APPROVAL ONLY:
 NOT FOR CONSTRUCTION

VERMONT
 MONTPELIER
BUELS GORE
 035

Designed	KJG	CS Project No.	14688
Drawn	WLC	Sheet No.	C/S3
Checked	MRW	Date	6/22/06

UPSTREAM END ELEVATION

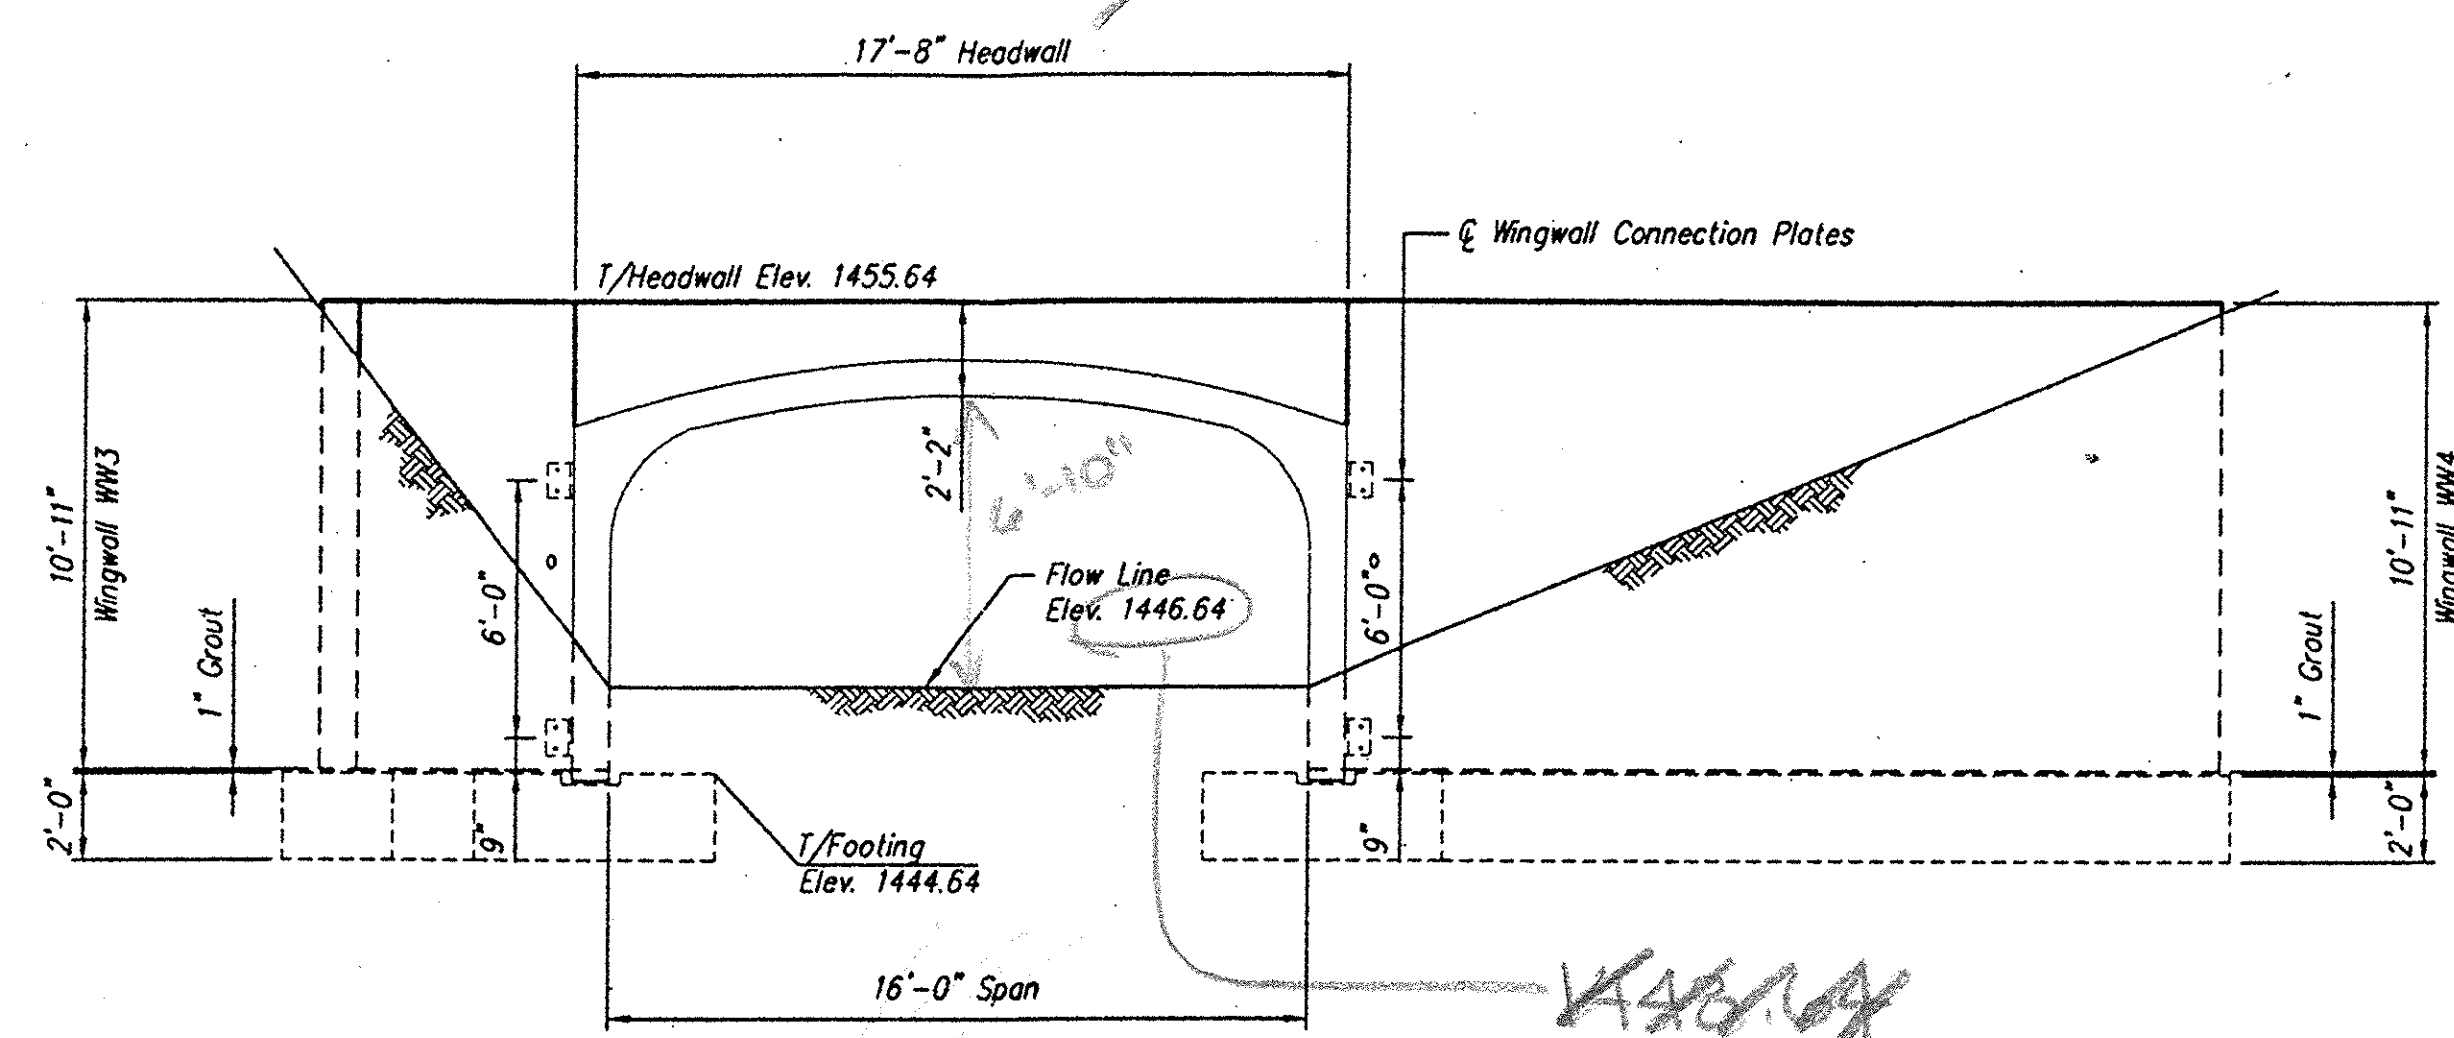
@ inlet
 @ outlet
 Buels design of headwall
 flow line to top of headwall
 = 1455.64
 = 8.77 + 9.02' (1444.64 + 2')
 on this plan
 1455.64 - 1446.64 = 9

need top inside to
 be at least
 $1448.64 + 6' 6.9''$
 1455.64
 $- 1454.64$
 2
 3

DOWNSTREAM END ELEVATION

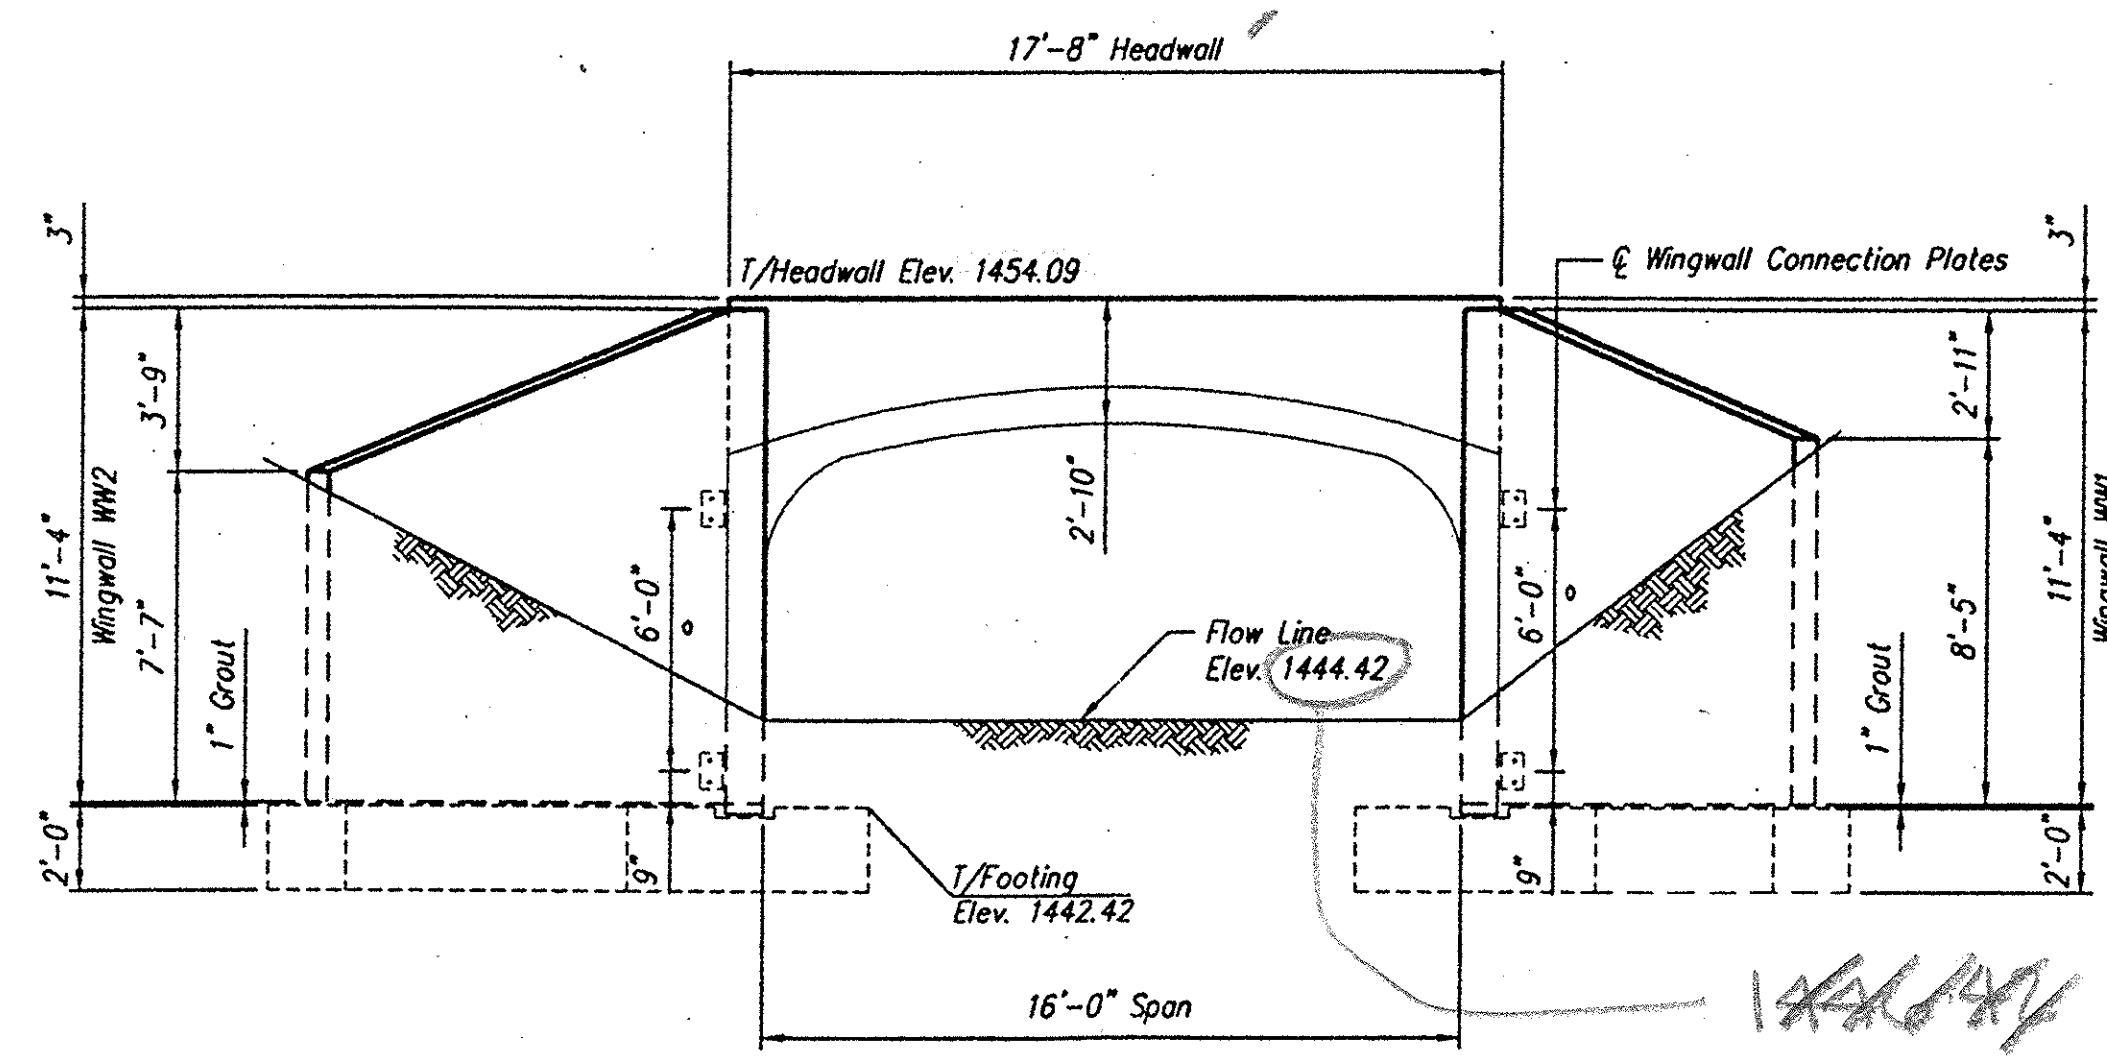
$1444.64 + 10'-11''$
 $- 2'-2'' = 1453.39$
 $- 1448.64$
 4.74

fty to inside top of
 arch = 1442.64
